Planning, Zoning, and Building Department

BOARD ACTION REPORT – APPEALABLE ITEM

Project Name: 2710 W. Atlantic Avenue
Project Location: 2710 W. Atlantic Avenue
Request: Class IV Site Plan, Landscape Plan, and Architectural Elevations.

---STAFF REPORT---

PROPOSED
SITE PLAN

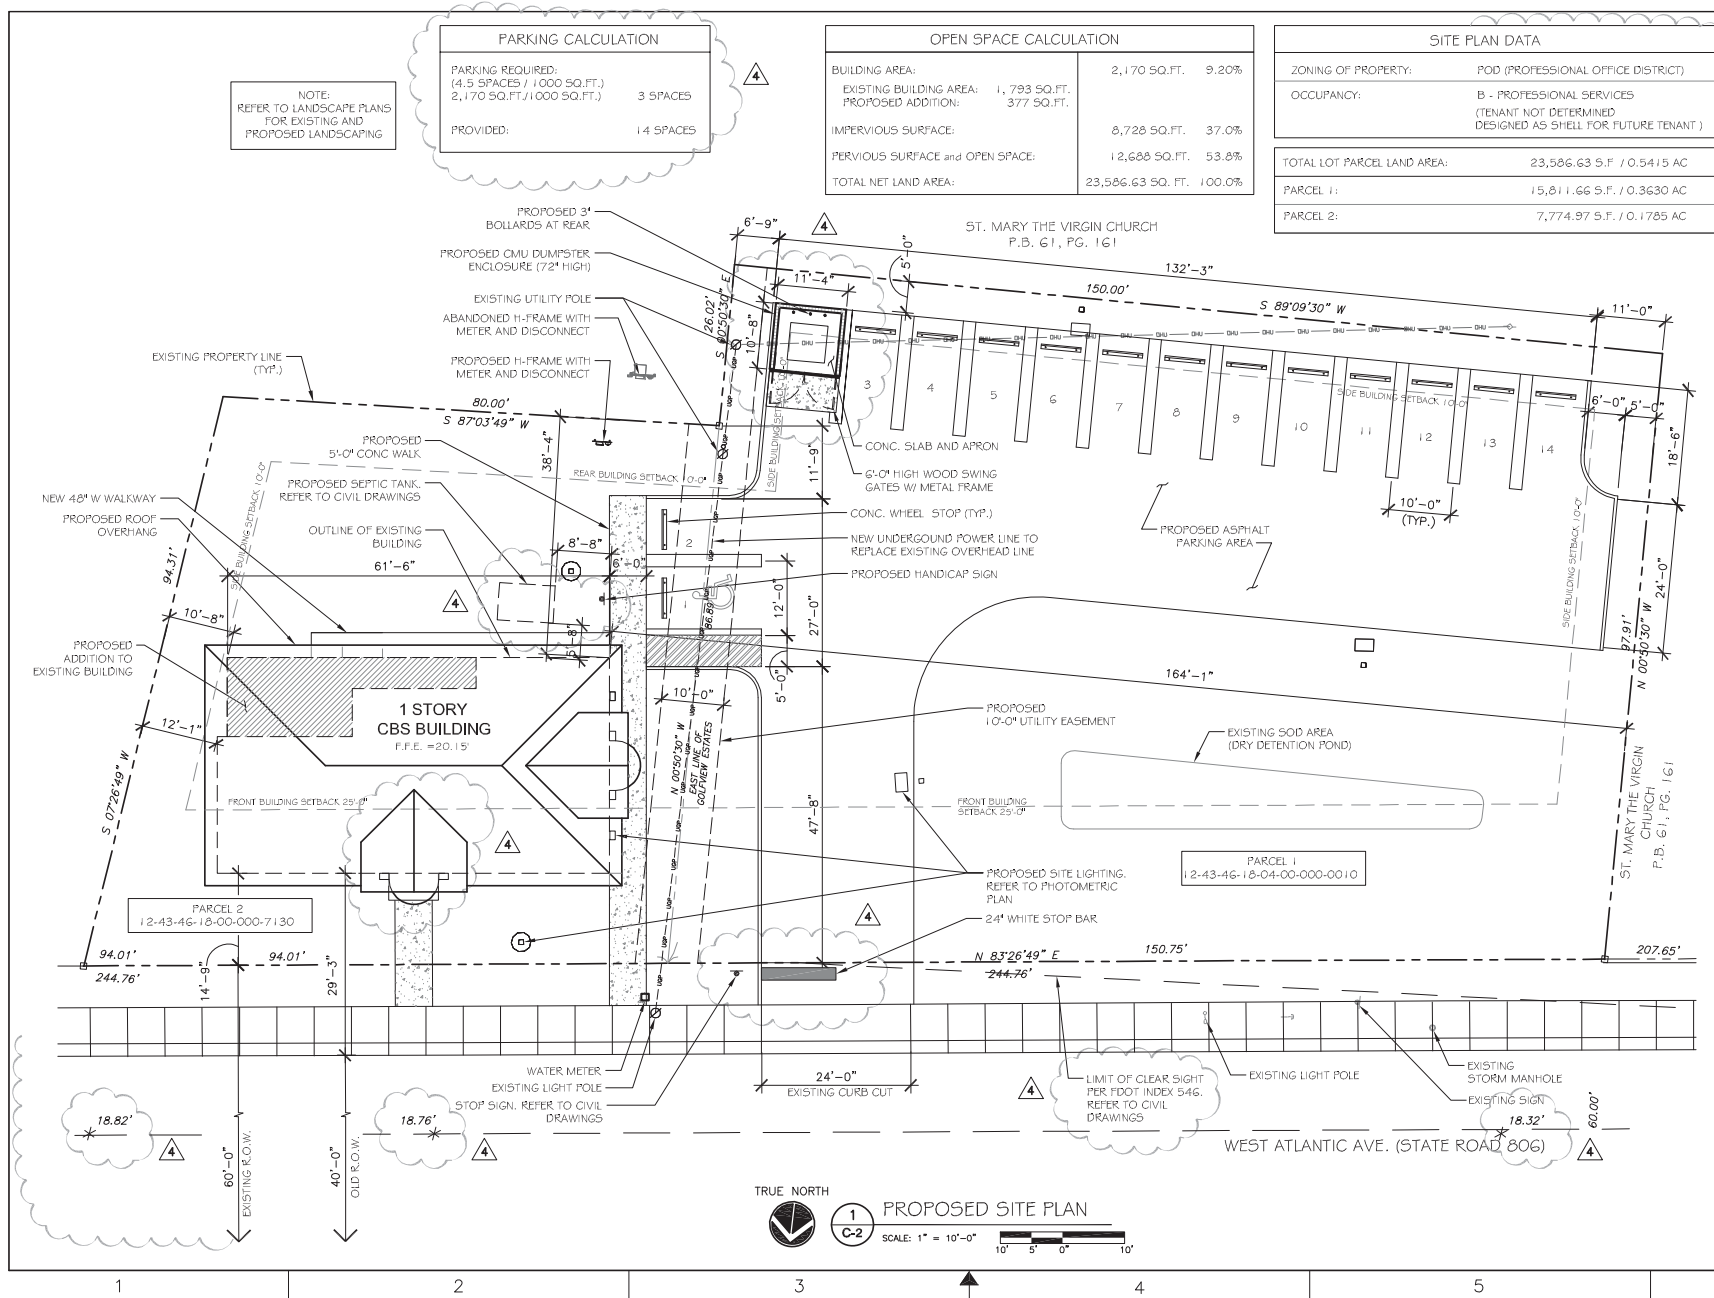
1. Prior to the issuance of a building permit, a unity of title is required.
2. Prior to Site Plan certification, the table on Sheet C-2 shall reflect the parking calculation in the staff report.
3. Prior to Site Plan certification, Sheet PH-1 shall be updated to demonstrate lighting does not exceed the maximum limit along the south and west property lines.

Sheet C-2 of the plan set does not accurately reflect the required parking for the project. Updating the table on the sheet to reflect the parking analysis in the table above is recommended as a condition of approval.

ELEVATIONS

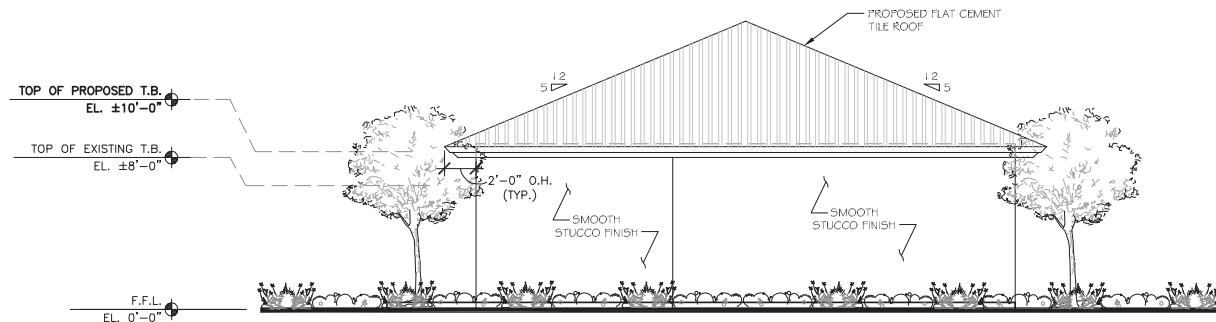
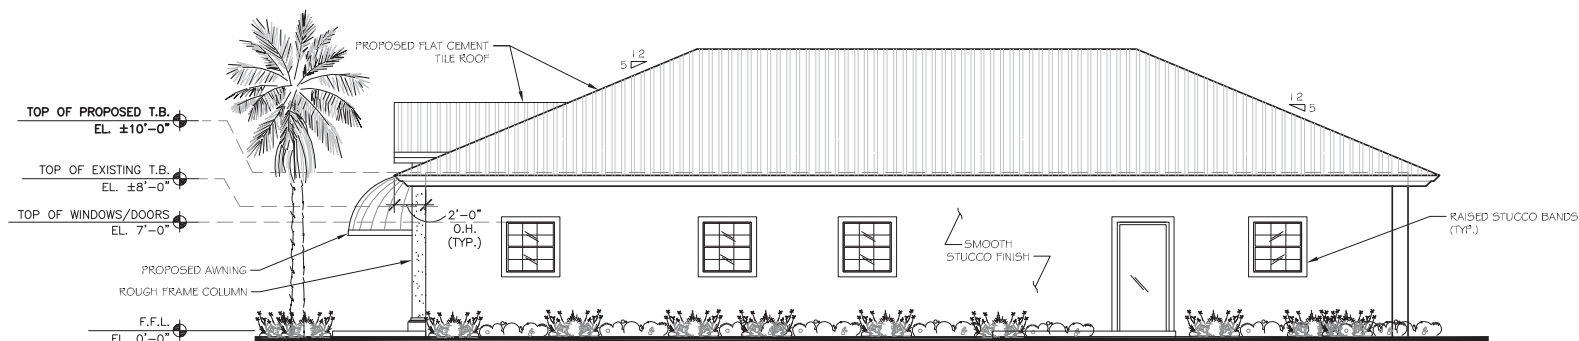
1. Prior to site plan certification, clarify and clearly label the roof material.

The renovation of the existing building is extensive and includes raising the ceiling height and adding a building entry facing the new parking lot. In order to maintain a physical presence on the main thoroughfare, a building entry with awning and light fixture faces West Atlantic Avenue. The west elevation has a new entry with similar characteristics. The proposed color palette is earth tones. The exterior walls are smooth stucco painted Eider White. The roof is labeled on the architectural elevations as a standing seam metal roof. The submitted rendering suggests barrel or cement tile. The awnings over the building entries will be canvas in a Walnut Stain color. The proposed changes to the building are harmonious with the surrounding area and will improve the appearance of the property. A positive finding can be made regarding LDR Section 4.6.18(E); however confirming the material and color of the roof is a recommended condition of approval.

PHOTOMETRIC
PLAN

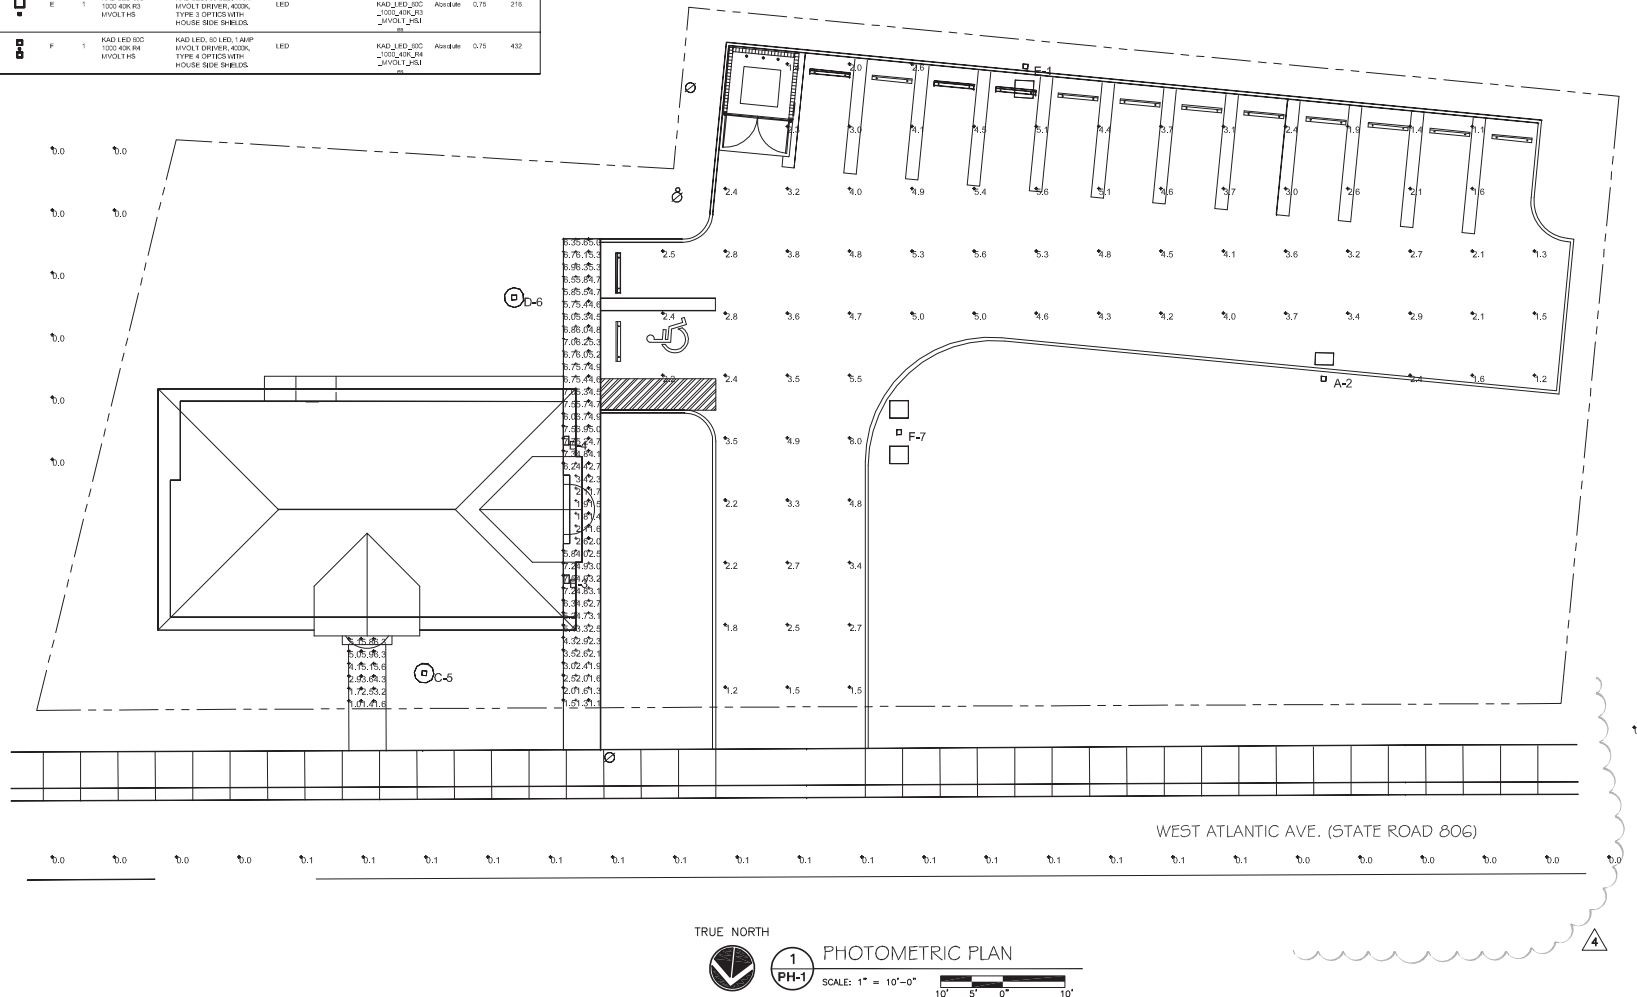
Section 4.6.8(B)(3)(b) regulates light spillage for outdoor parking areas and commercial sites. To minimize light spillage from the site and reduce urban-glow for development, the maximum allowable illumination at the property line adjoining any parcel or right-of-way is .25 foot candles. The proposed design meets the criteria along W. Atlantic Avenue. The submitted photometric indicates light levels of 1.5 foot candles in the parking area near the vacant lot to the west and 2.0 foot candles near the south property line, adjoining the neighboring church. Levels are not provided specifically at the property line. It is important to note that the property is fairly isolated, surrounded by the golf course, a large church property, and a vacant parcel. Updating the plan on sheet PH-1 to demonstrate lighting does not exceed the maximum limit along the south and west property lines is a recommended condition of approval.
